MultiCare Good Samaritan Hospital Kitchen

PHASE 1 CONSTRUCTION DOCUMENTS

City of Puyallup Review For Compliance No. 1
6/12/2025

SHEET NUMBER
G05-01

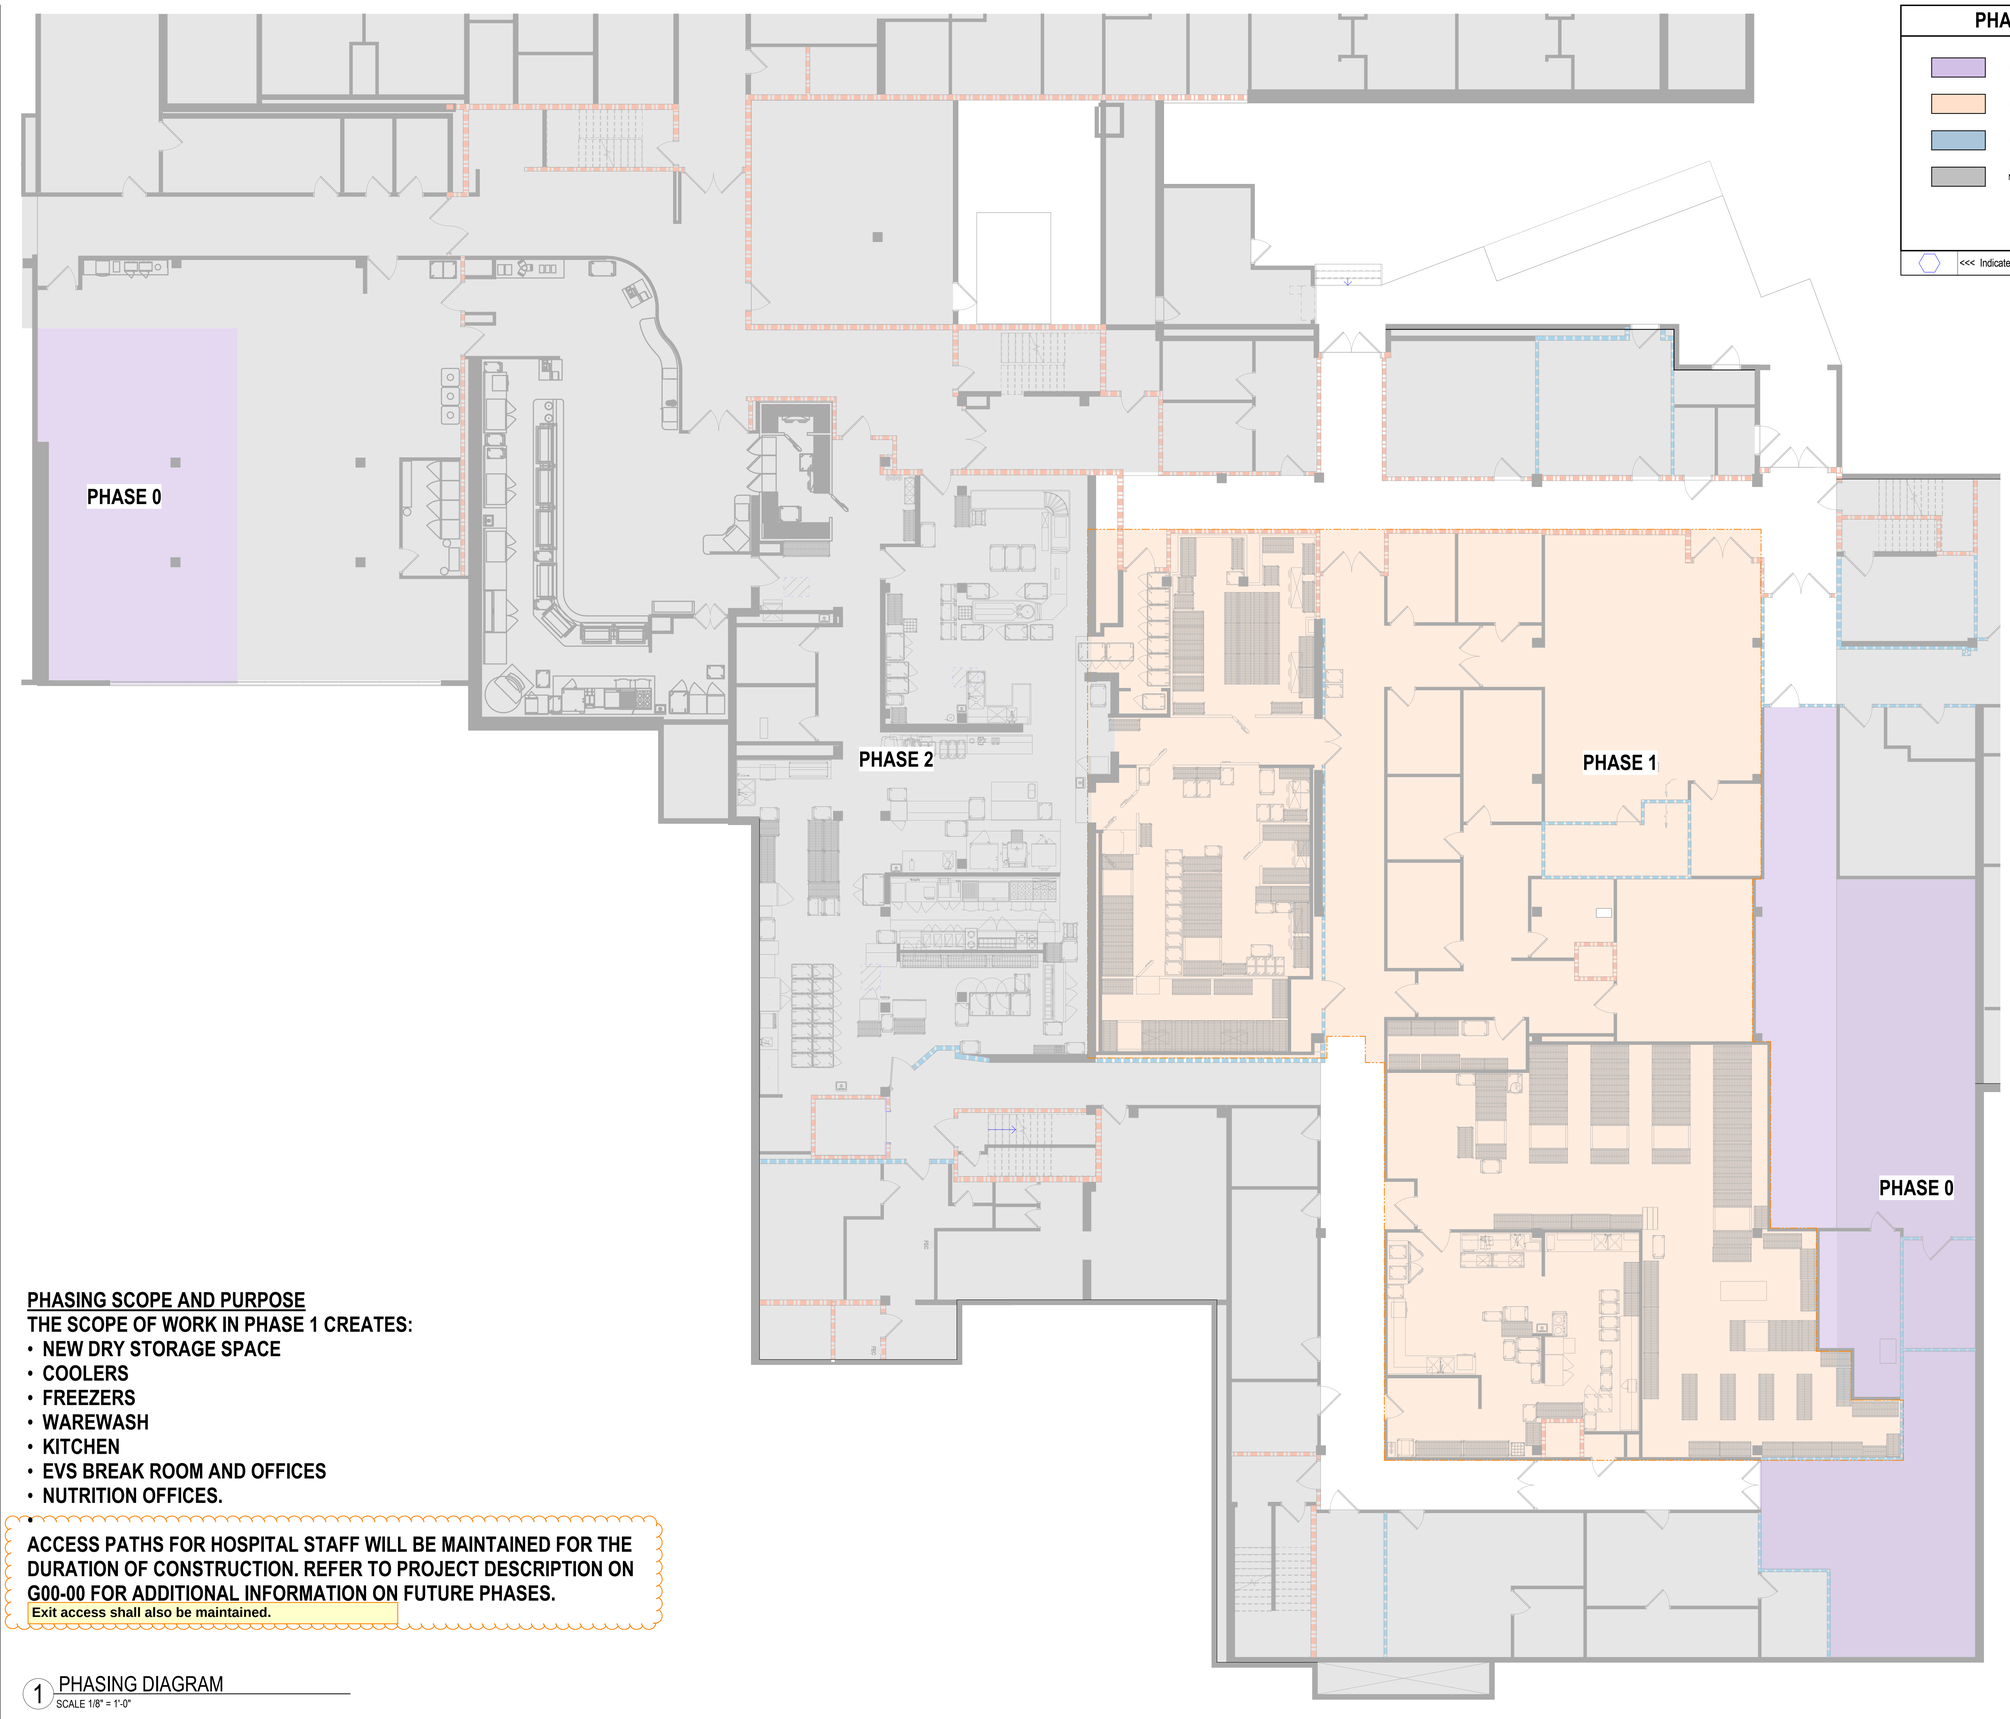
Looking for details for fire resistant penetration, including electrical, plumbing, mechanical, etc.
Please provide penetration type and listed assembly details.
G05.01

1 DEMOLITION PLAN LEVEL 01 - PHASE 1
SCALE 3/16" = 1'-0"

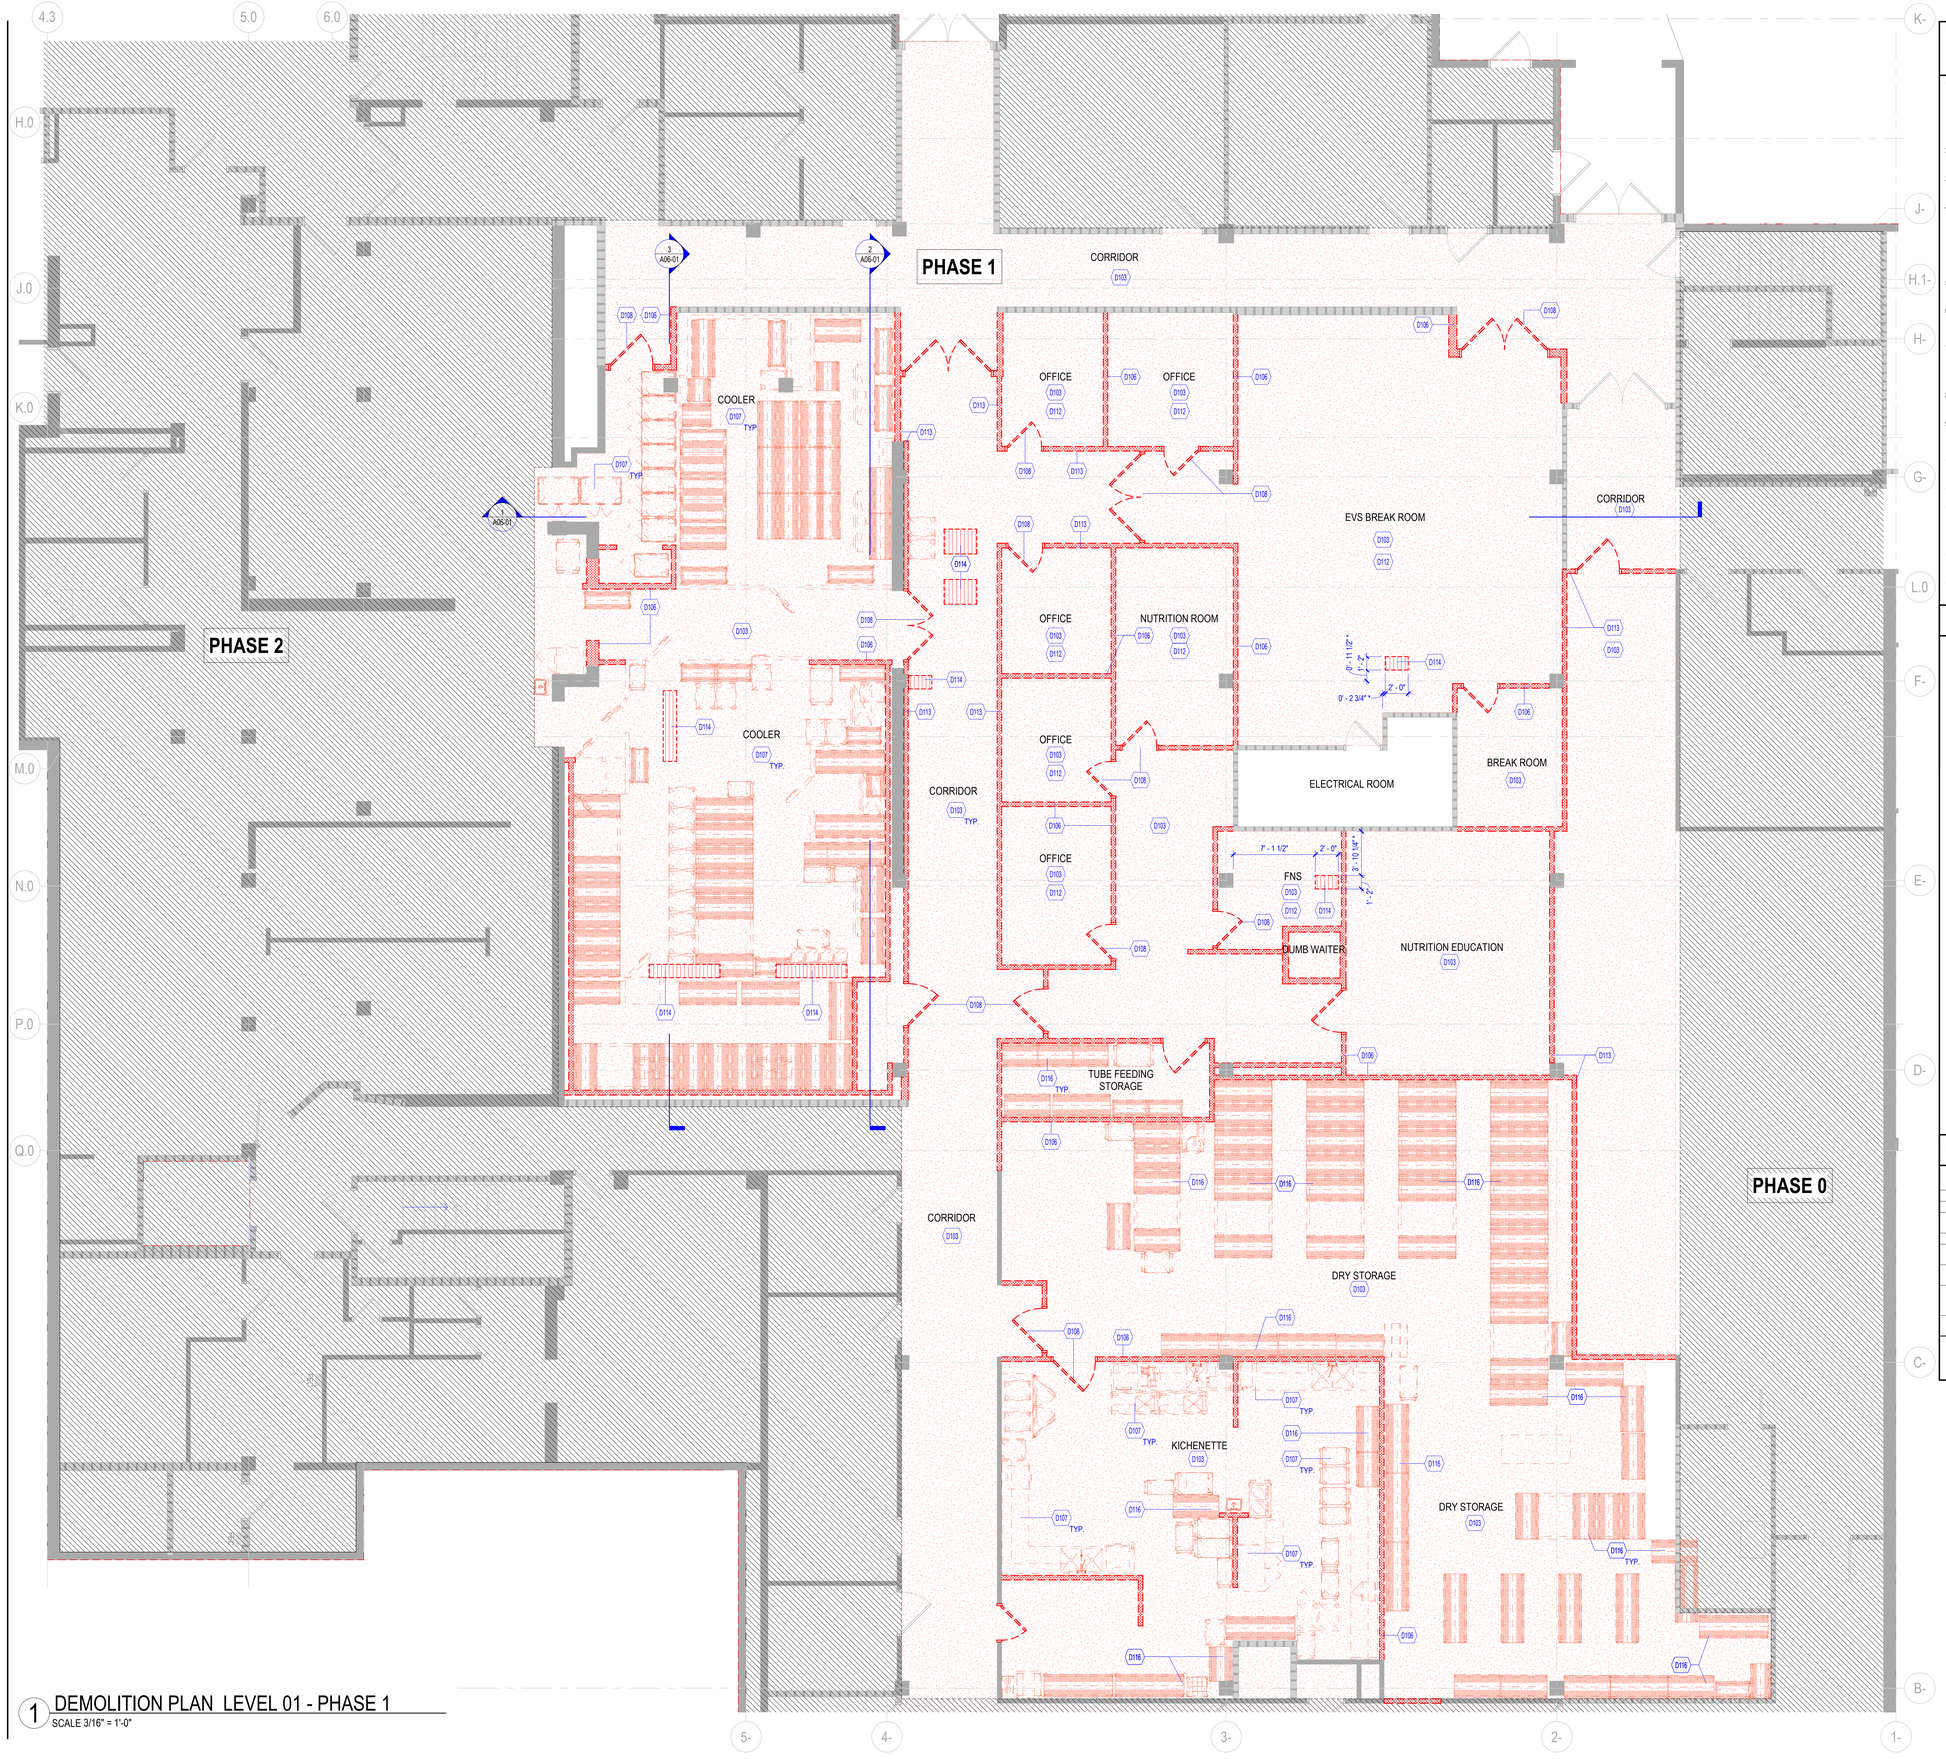
A04-05 Is this scope of demolition work intended to be part of Phase 1 A or B? A04-05 and other reference sheets. See Sheet 06.01

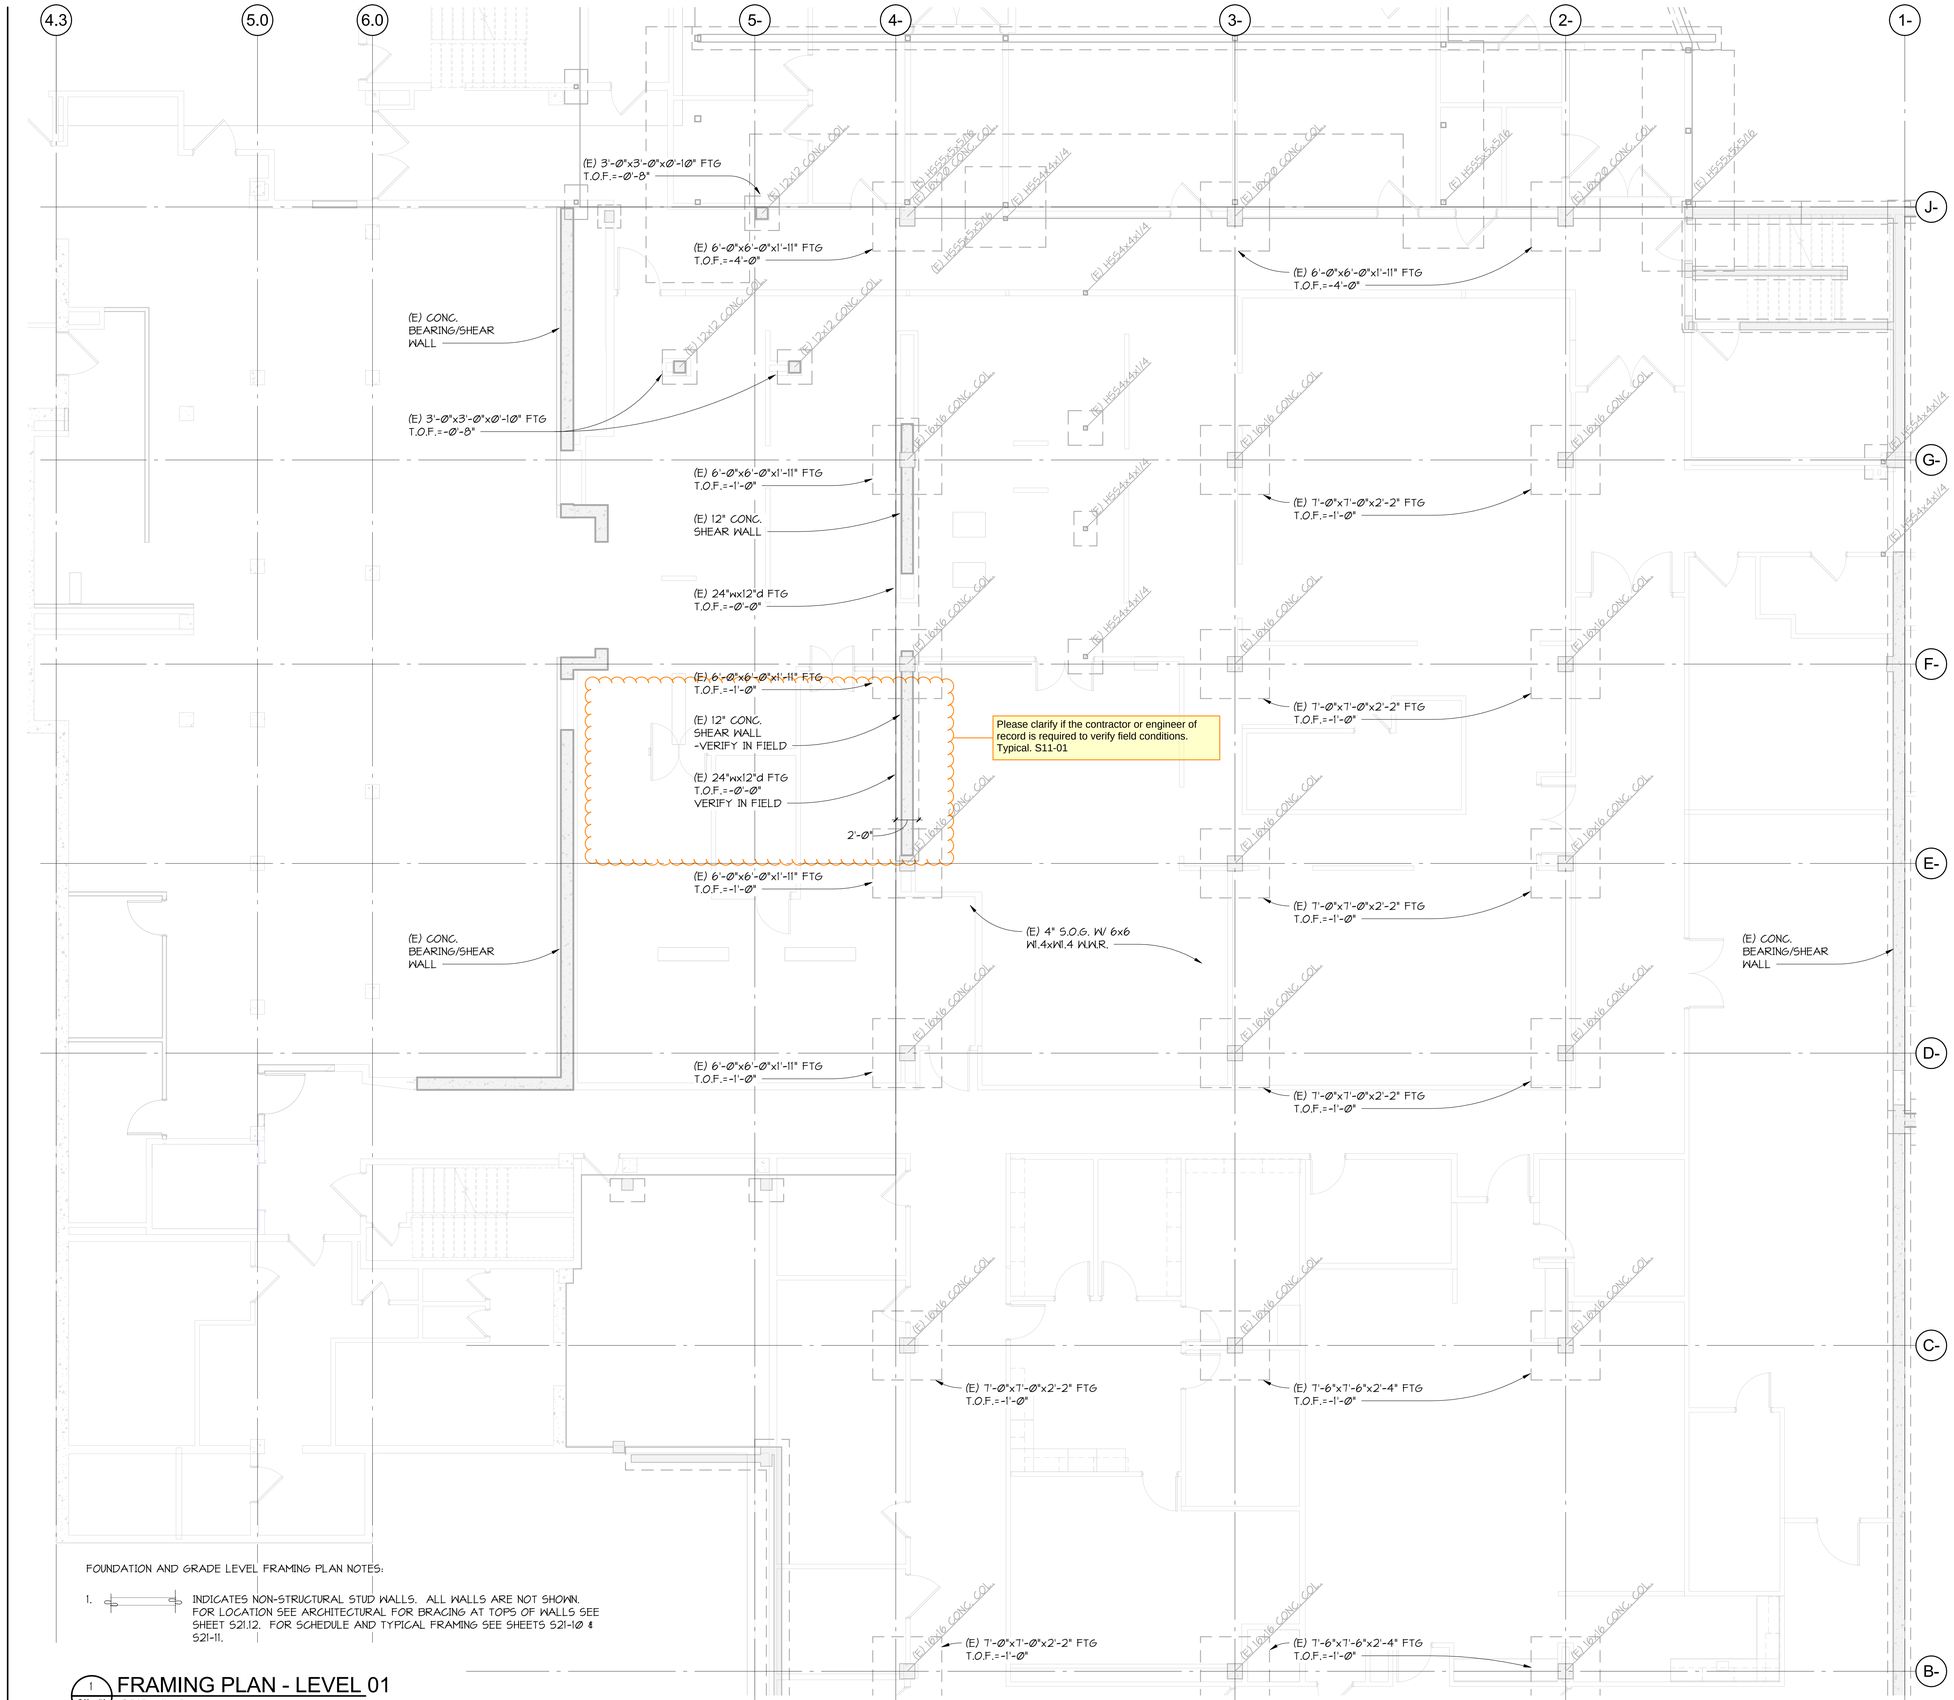
Please clarify if the contractor or engineer of record is required to verify field conditions. Typical. S11-01
